**Re: El Rancho Grande Unit 10 & 11 subdivision Drainage Report
Engineer's Stamp dated 6-19-03 (N9/D4)**

Re: El Rancho Grande Unit 10 & 11 Subdivision Drainage Report (N9/D4)

**DRAINAGE STUDY
FOR
EL RANCHO GRANDE UNITS 10 AND 11**

DEVELOPED CONDITIONS BASIN MAP

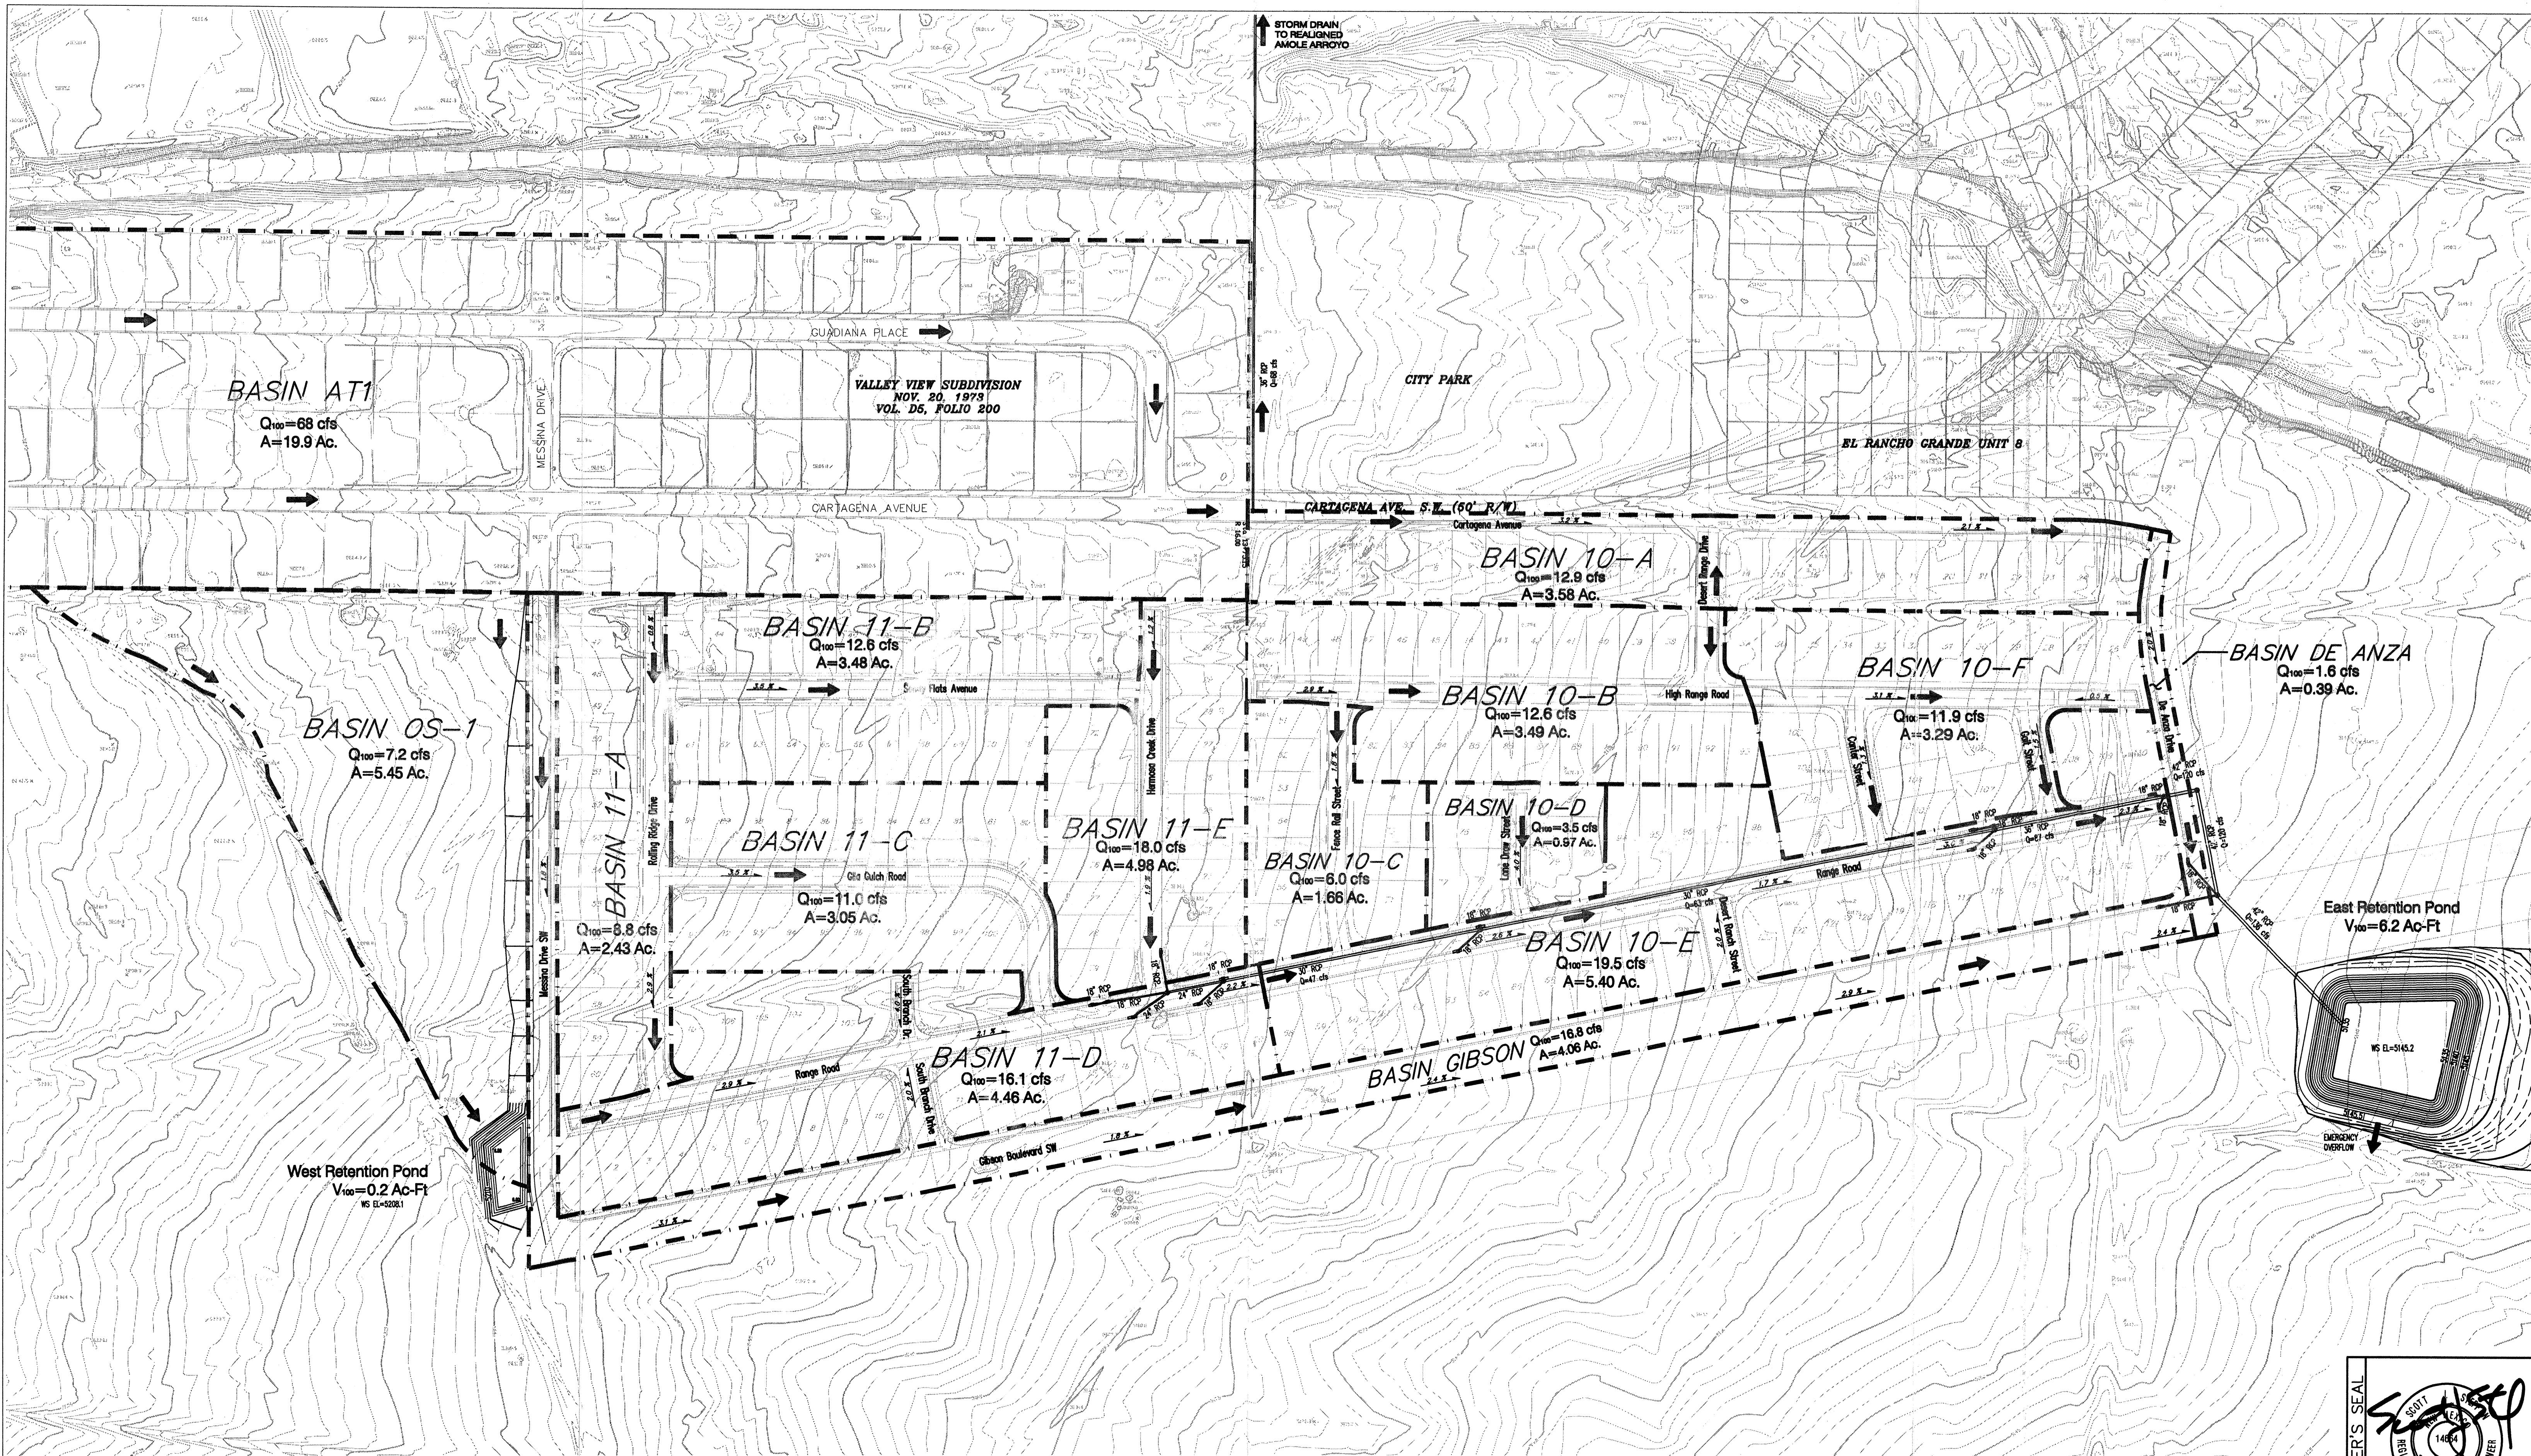
The two offsite ponds are located on property owned by Curb, Inc., the same owner that is developing Units 10 and 11. If written permission is still required please let me know so that we can provide this under separate letter. Drainage easements for the swale, ponds and overflow arroyo will be provided prior to Final Plat approval. In addition, a Drainage Covenant and Agreement will be provided for both ponds prior to Final Plat. The water surface elevation for both ponds have been added to the basin map and grading plan.

EL RANCHO GRANDE UNIT 8 GRADING PLAN

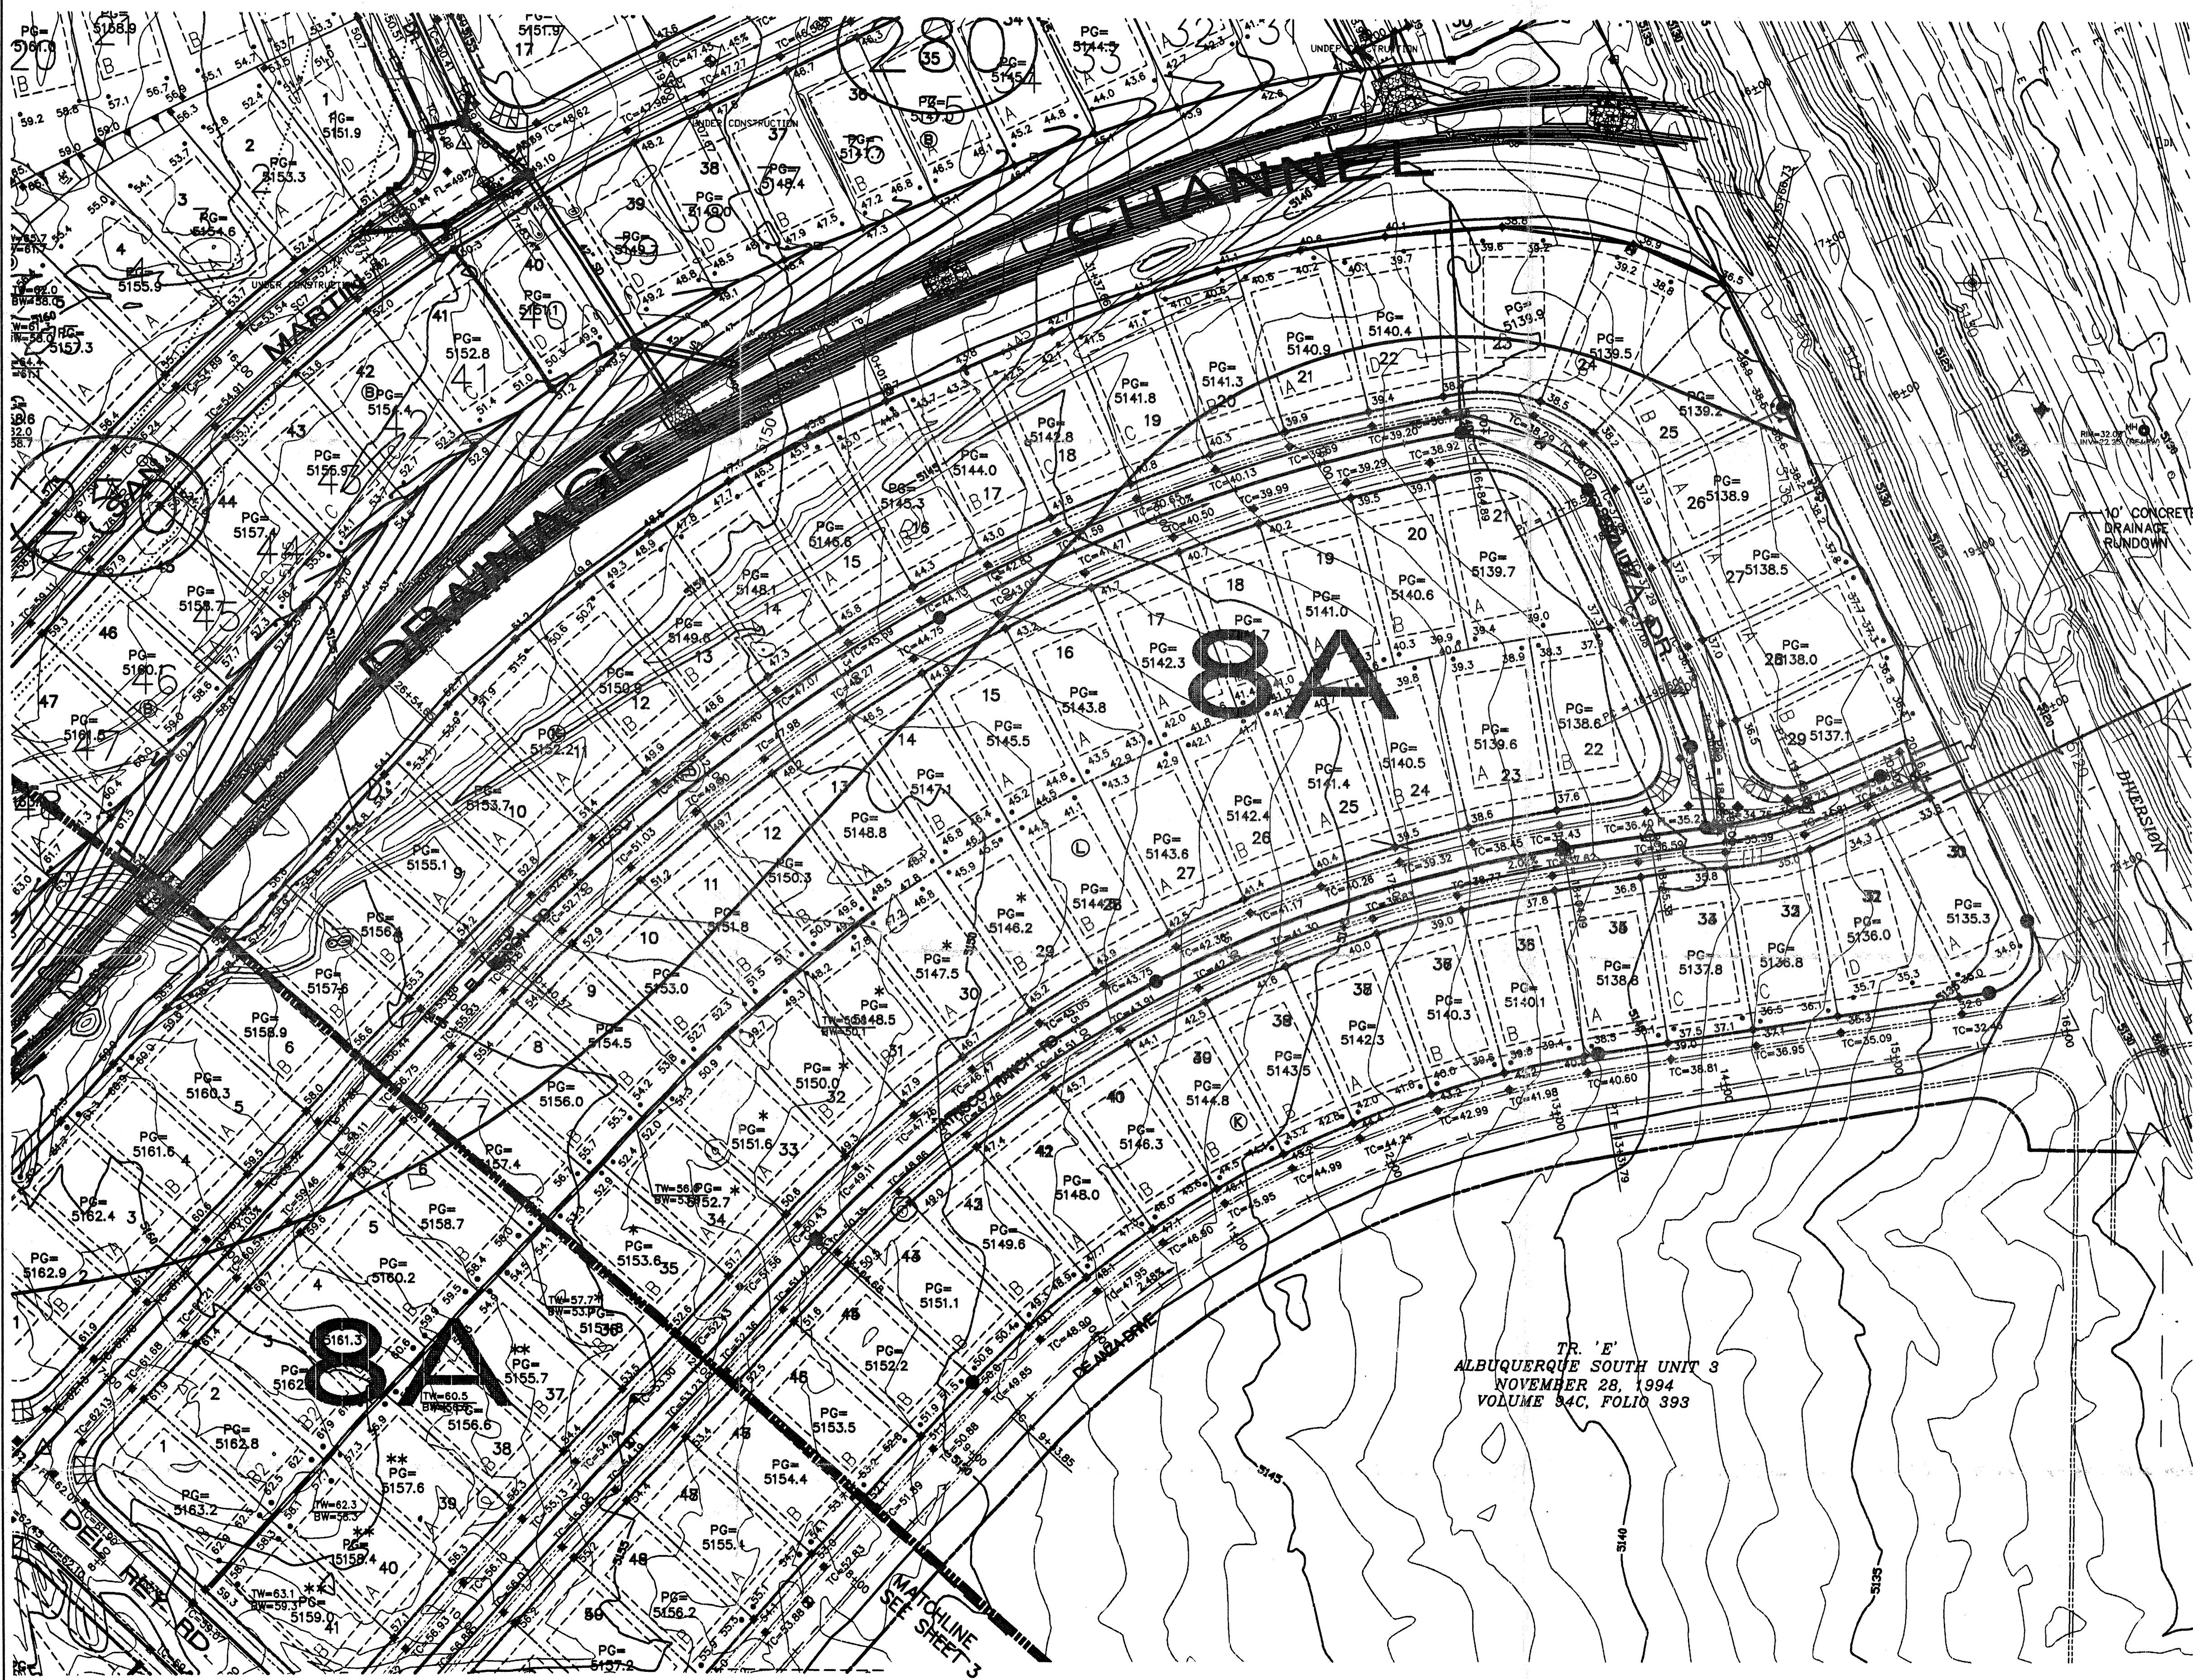
The section on off-site flows has been revised to discuss how flows in Cartagena Avenue from the Atrisco Village subdivision will be managed. Excerpts from the El Rancho Grande Unit 8 drainage report, including the grading plan, are included in the report to explain how flow from De Anza Drive and the north half of Cartagena Avenue adjacent to Unit 8 is conveyed to the Amole Arroyo.
